**Amendment C226 Incorporated Document : ID-2013-2  
Australian Broadcasting Corporation Melbourne 120-130 Southbank  
Boulevard and 102-118 Sturt Street, Southbank**

**3 December 2013**

### MINISTERIAL REFERRAL

<b>Application number:</b>	<b>ID-2013-2</b>
<b>DTPLI Application number:</b>	Amendment C226
<b>Applicant / Owner / Architect:</b>	Meredith Withers / ABC / Cox Architecture
<b>Address:</b>	120-130 Southbank Boulevard, SOUTHBANK VIC 3006, 102-118 Sturt Street, SOUTHBANK VIC 3006
<b>Proposal:</b>	<p>Planning Scheme Amendment C226 - Melbourne Accommodation Project to allow:</p> <p>The use and development of the land, including demolition of the building at 102- 118 Sturt Street Southbank, and partial demolition and alterations and additions to the building at 120 Southbank Boulevard to allow construction of an integrated ABC Southbank Centre for the purposes of, but not limited to: Office, Media Production Studio, Food and Drink Premises (other than Hotel and Tavern), Orchestral Rehearsal and Public Performance Spaces and display of business identification signage generally in accordance with the following 'Incorporated Plans' prepared by Cox Architecture and titled 'ABC Mel

01 NORTH ELEVATION  
1:250

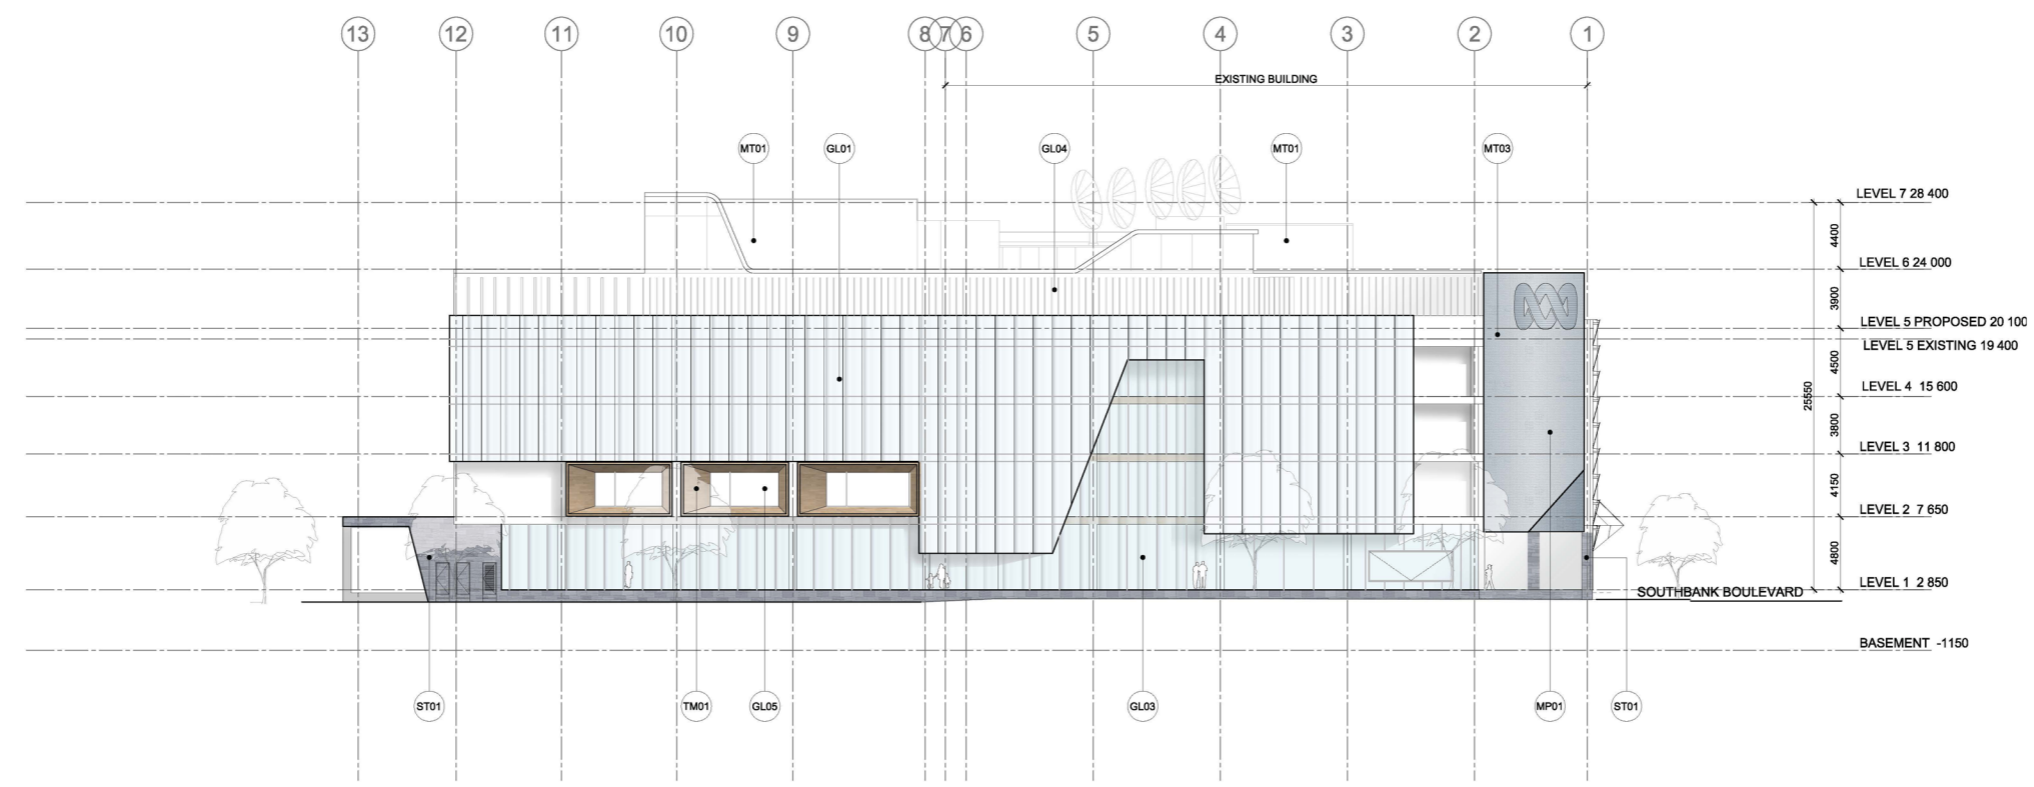
Limited detail is provided in relation to the ABC logos, however it has been submitted that these signs are concepts and require further development. Consequently additional detail of the signs should be provided and appropriate standard signage conditions should be included in the Incorporated Document. It is also recommended that the Incorporated Document should exclude Clause 52.05 Advertising signs from applying to the land.

- a. Dimensions and details (materials, colours etc.) of the projections over the northern boundary
  - b. Additional detail of the ABC logos (business identification signs) located on the north and eastern elevations. Additional detail should include dimensions, materials and colours and illumination levels (if appropriate)

Project Number: 311001  
 Drawing Number: A-3102  
 Drawing Title: EAST ELEVATION  
 Scale: 1:250@A1  
 Revision: 04

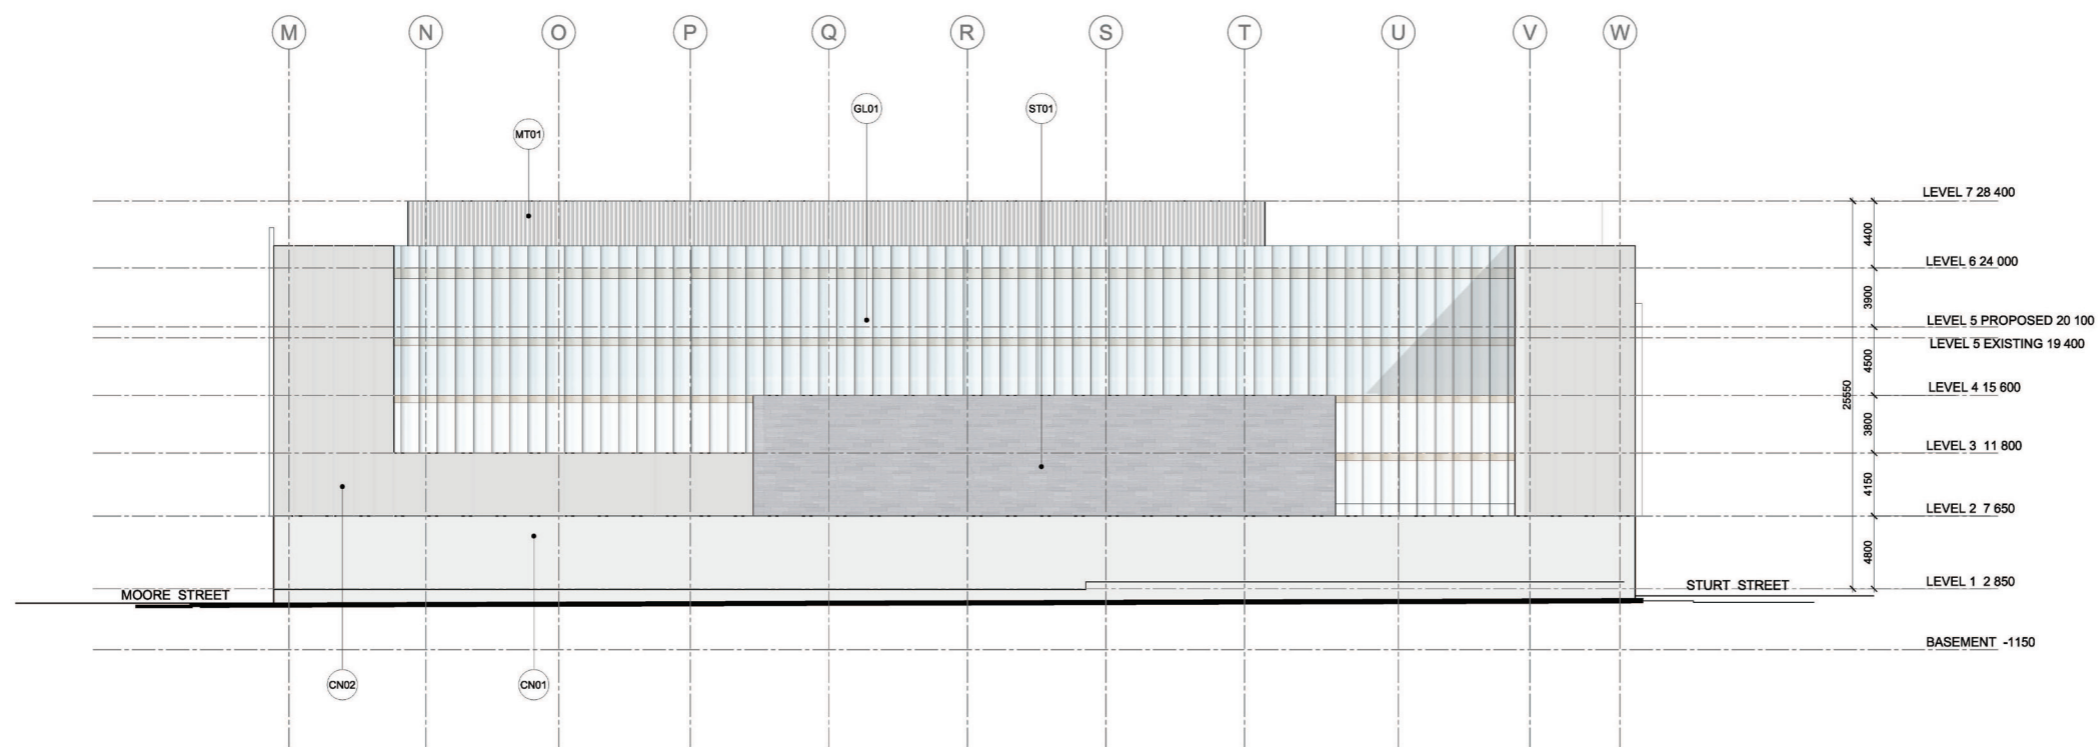
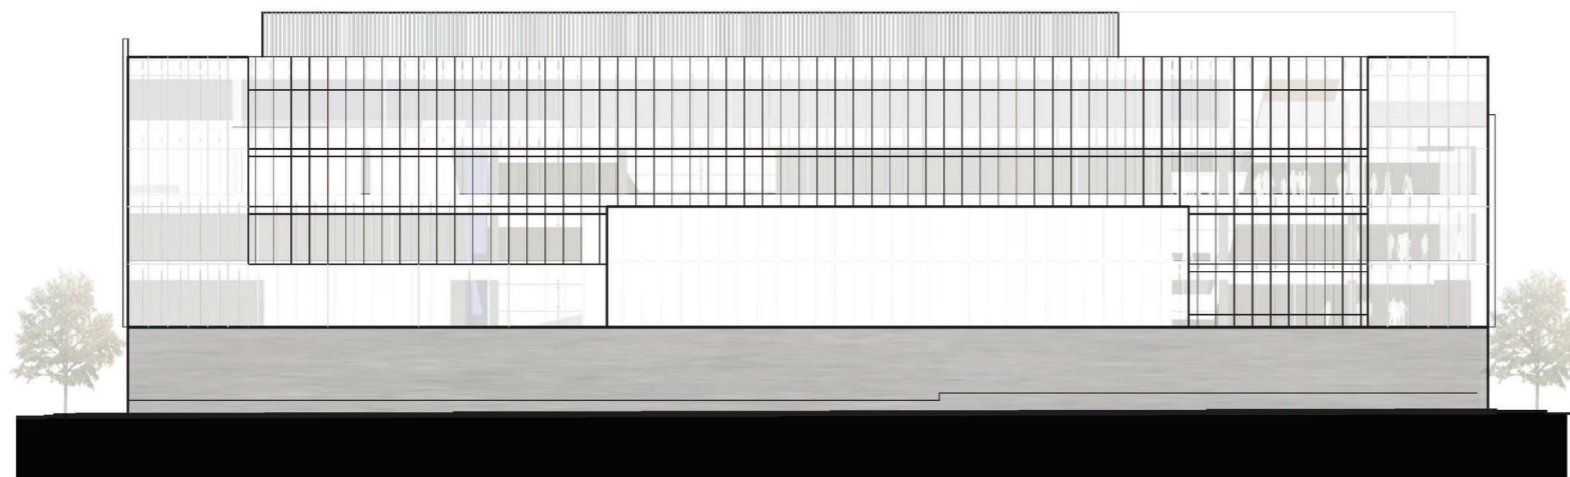
The design treatment of the Moore Street frontage is less successful and it is recommended that further design work be undertaken to provide an attractive and engaging ground floor frontage. Although it is acknowledged that essential operations such as loading and unloading and storage are required along this frontage, greater transparency and activation of the ground level plan should be provided, particularly as this area transitions to nearby residential properties.
